PROJECT: Meadows Multifamily

CITY OF LAS VEGAS		DATE:
INTER-OFFICE MEMORANDUM		December 16, 2020
TO: Land Development Services Department of Building & Safety		FROM: Albert Sung, P.E. Flood Control Project Engineer Department of Public Works
SUBJECT:	Drainage Study for:	COPIES TO:
	Meadows Multifamily	Wood Rodgers, Inc.
Cross Streets:	NEQ of Meadows Lane & Decatur Blvd.	Meadows Owner, LLC
File Number:	F:\Depot\DSMemos\DS5291B.doc	Bart Anderson, P.E., DevCo
Parcel Number:	139-31-111-010	
Zoning Action:	SDR-76721 & VAR-76720	
FEMA Flood Zone	YES	NO X
Proposed Storm Drain	YES	NO X

Addendum #1 to the
Technical Drainage Study
for
Meadows Multifamily
Meadows Ln @ Meadows Mall St Project

RE: Addendum #1 to the Technical Drainage Study for Meadows Multifamily (DS 5291)

DRAWING
C4.01
7 OF 17 SHTS

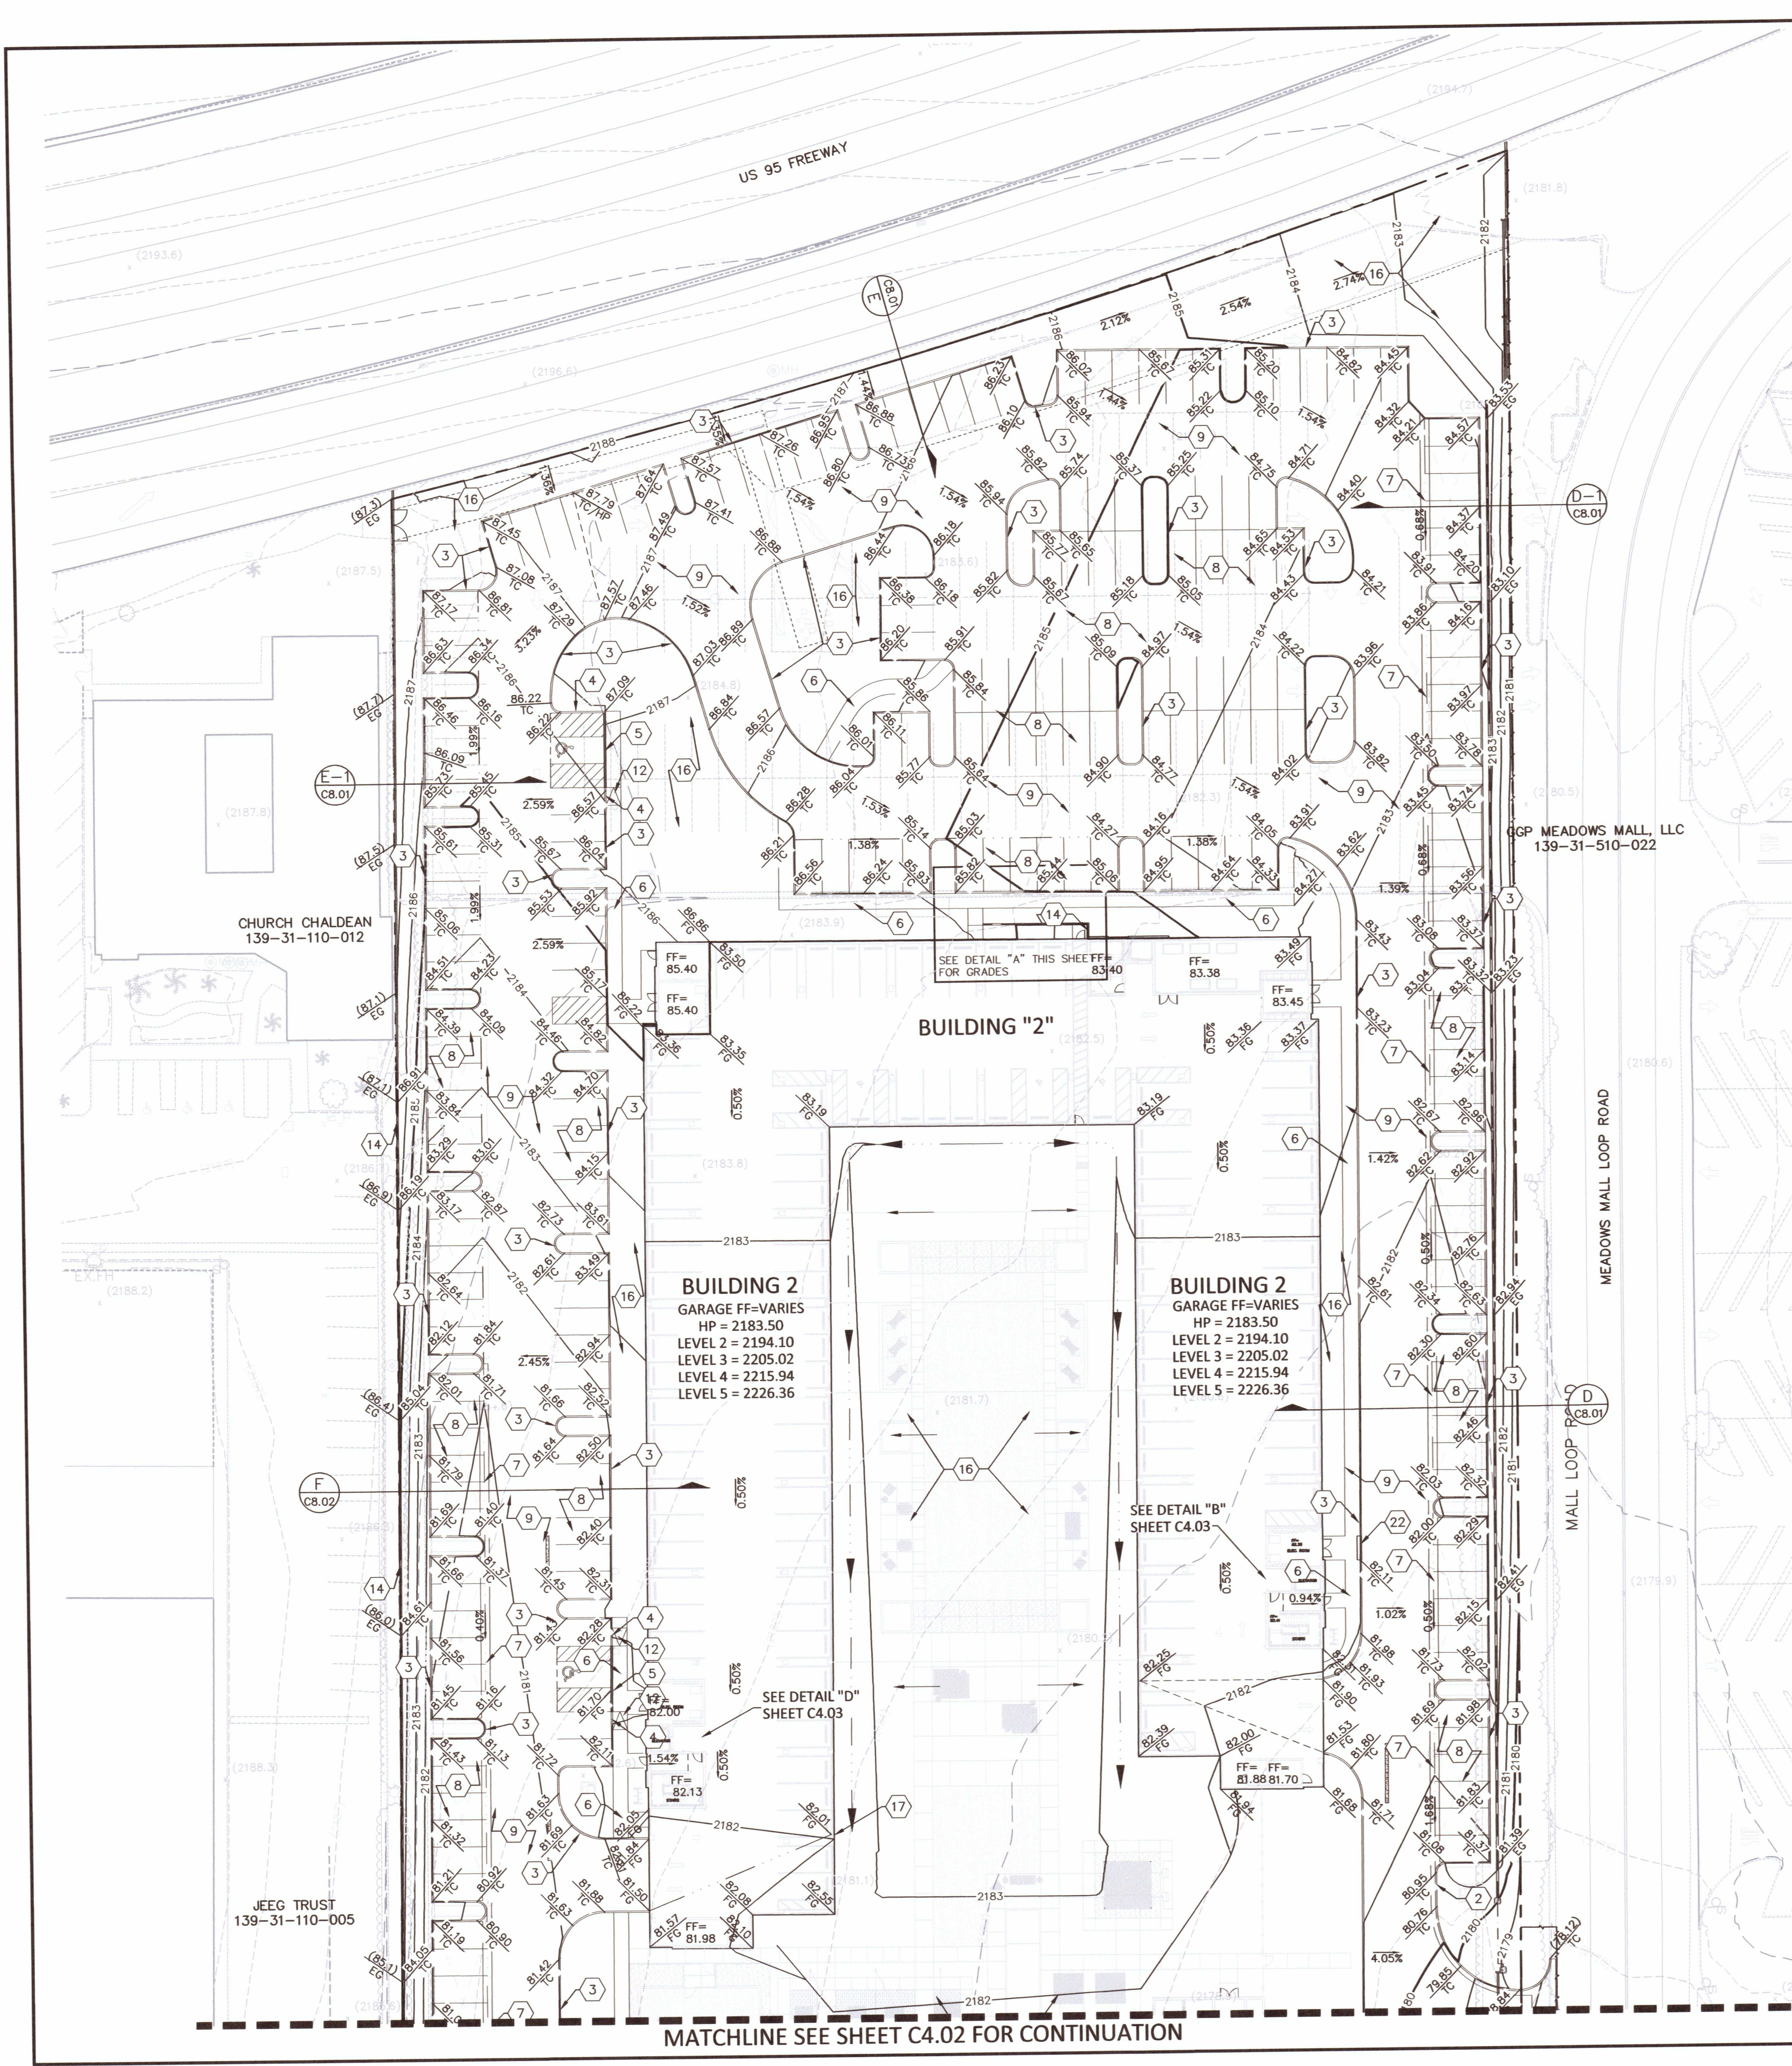
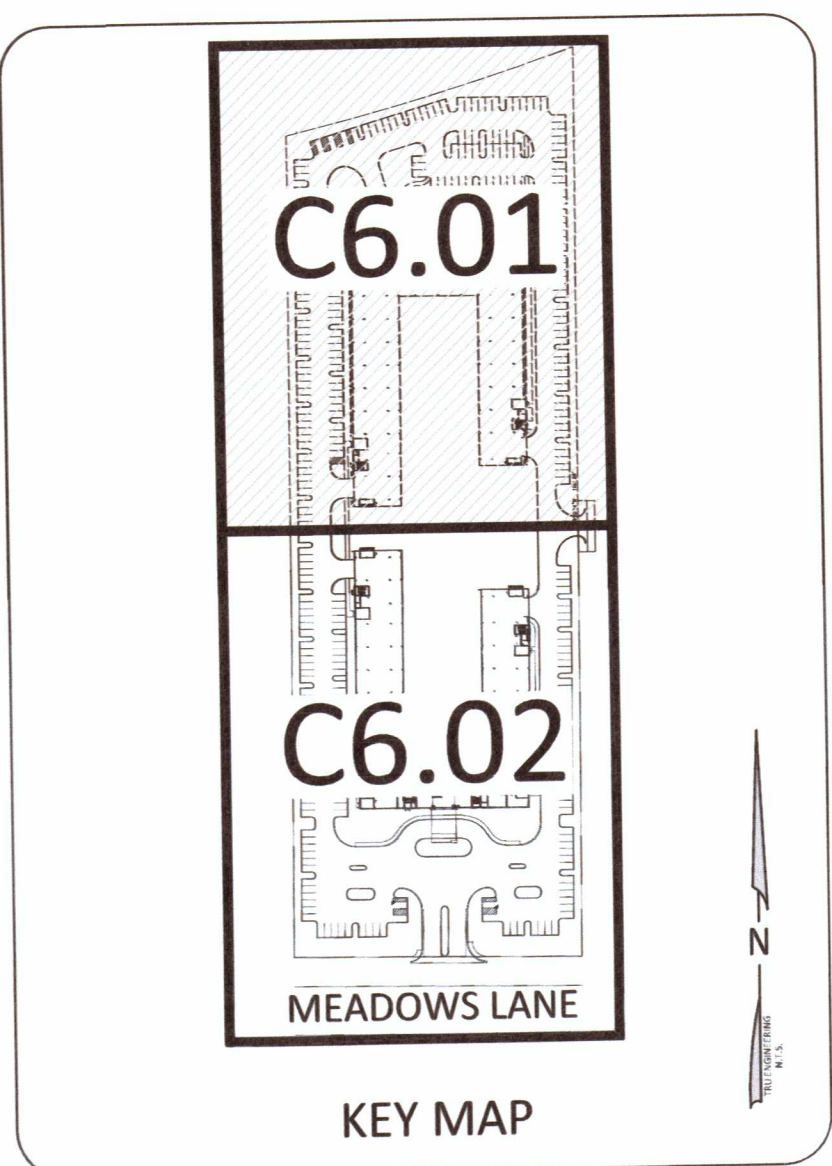
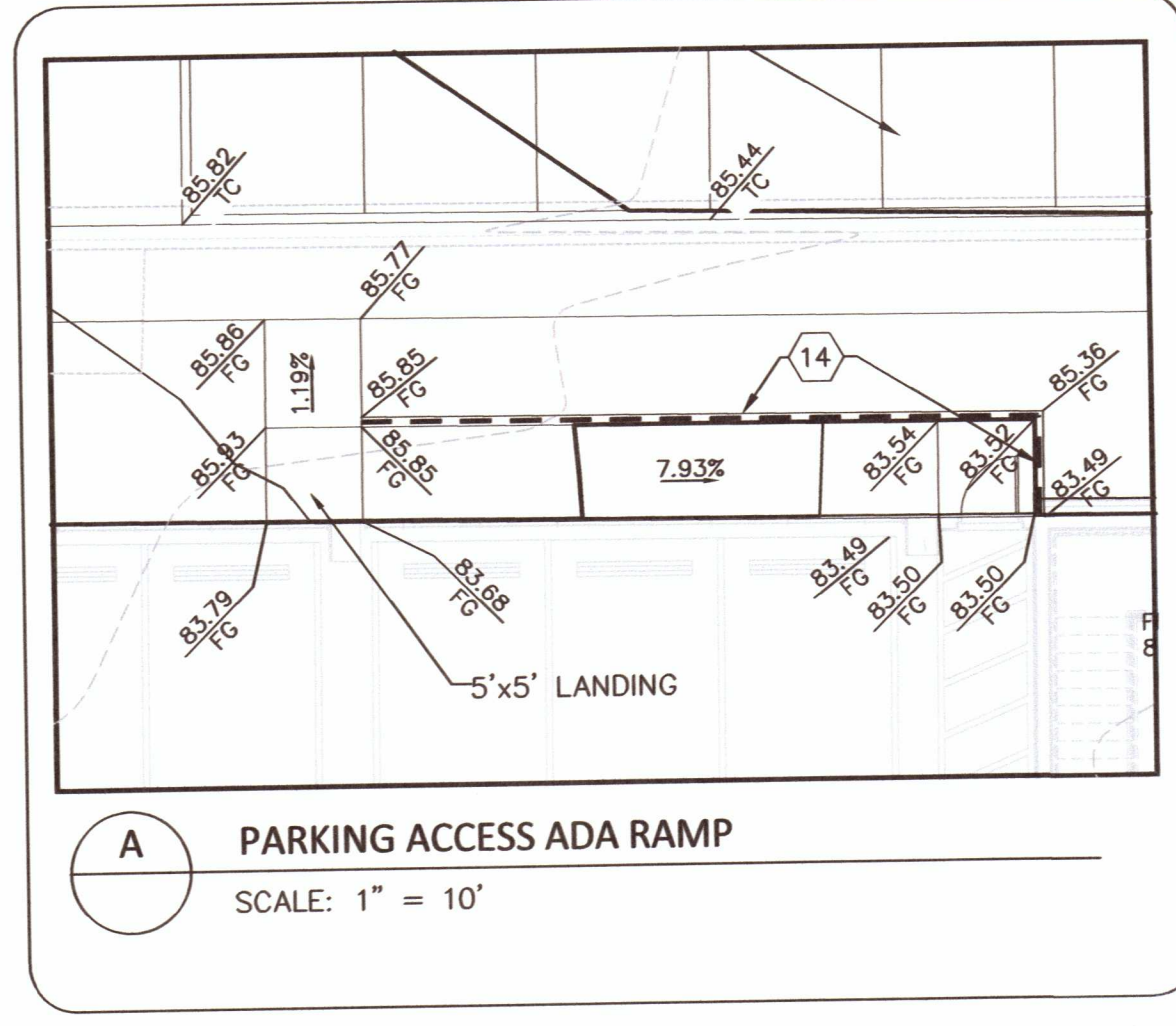
Comment 11 Identify the existing storm drain in Meadows Lane and label with City of Las Vegas recorded drawing number on the grading plan.

Comment 12 Provide a note on the grading plans: All onsite storm drains and the associated facilities are Privately Owned and to be Privately Maintained by the property owner.

Response 11 *The existing storm drain in Meadows Lane is a 24" RCP per CLV DWG# 107-V1137.*

Response 12 *The appropriate note has been added to the grading profile drawing.*
